Docket Item # 12 & # 13
BAR CASE # 2018-00051 &
2018-00052

BAR Meeting
April 4, 2018

ISSUE: Partial Demolition/Capsulation and Addition/Alterations

LOCATION: 312 South Washington Street

Figure 5. Proposed roof plan with staff highlights where six feet of mechanical screening may be unnecessary.

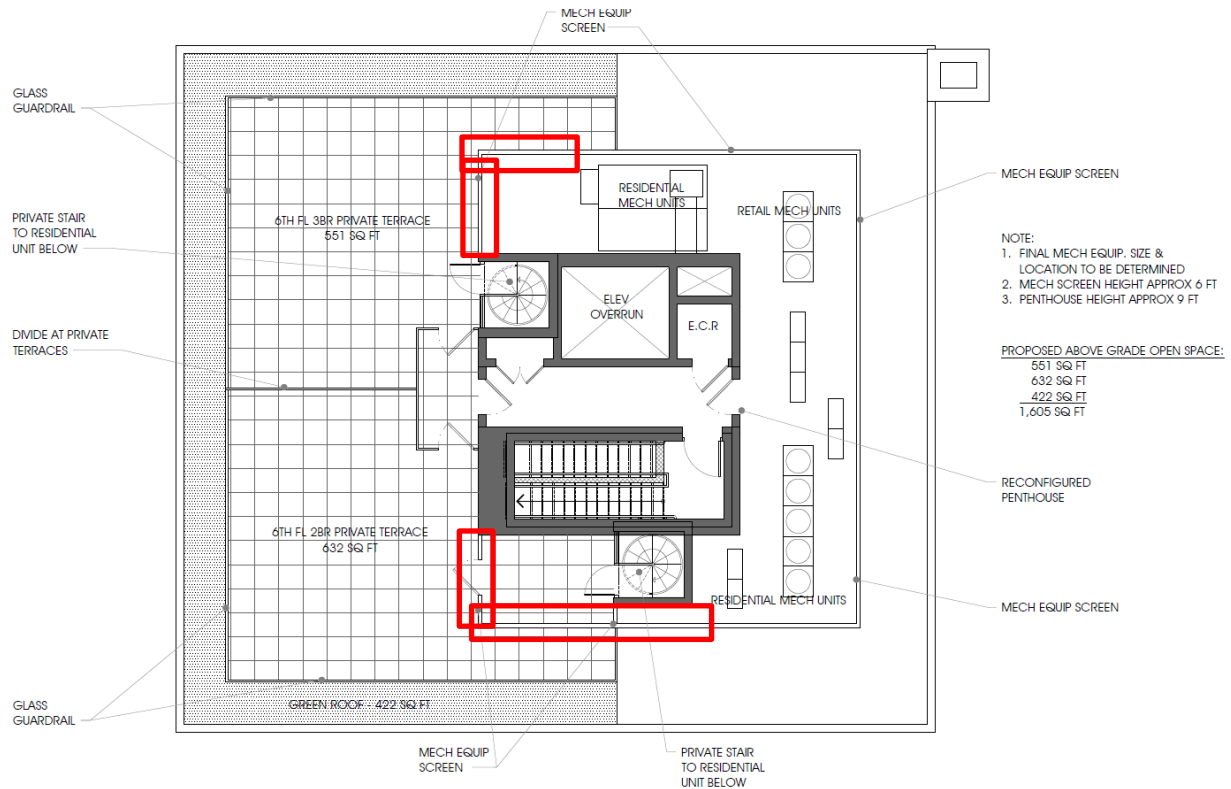
The zoning ordinance requires the concealment of all rooftop mechanical equipment, though the BAR has the authority to waive the screening requirement and did so here in 2001. In this case, the applicant proposes metal screening at six feet in height around a significant portion of the roof. Staff believes that the proposed screening is well over what is required and may have a greater visual impact than necessary. Therefore, staff recommends that the height and location of the screening be reduced to what is absolutely necessary and notes that this can be resolved during the building permit phase of the project.

2. The brick wall and wood fence may be no taller than six feet in height.
3. Work with staff to determine the minimum height necessary to effectively screen the rooftop mechanical equipment from public way; including the elimination of the mechanical screening on the terrace portion where there is no functional need for screening.

A PARTIAL ENLARGED WEST ELEVATION AT BRICK SCREEN WALL
3/8"=1'-0"

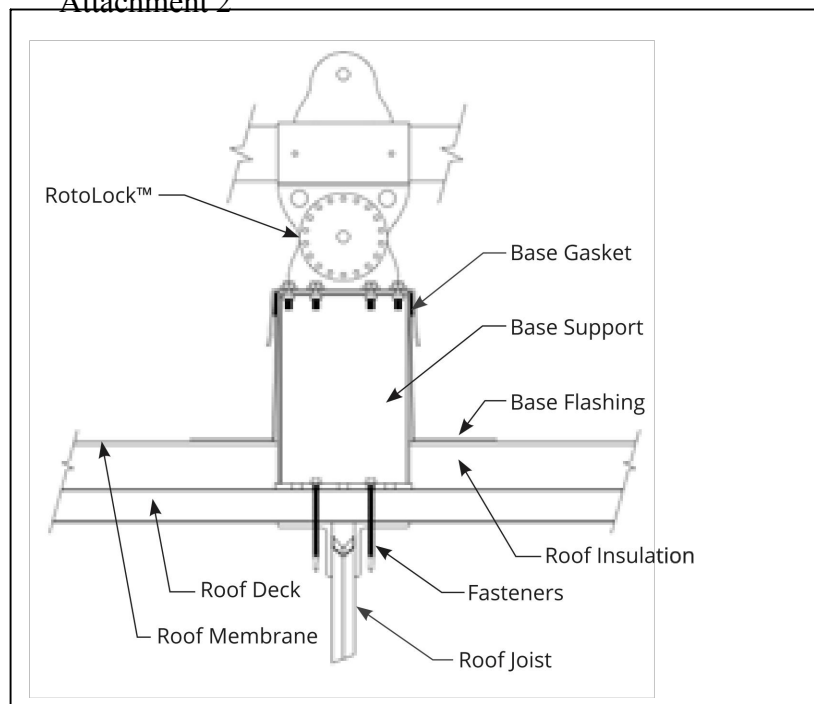
- Reconsider the proposed brick screen wall with cast stone pier caps and synthetic wood sliding gate. Consider the impact this proposed brick screen wall will have on the adjacent historical church.
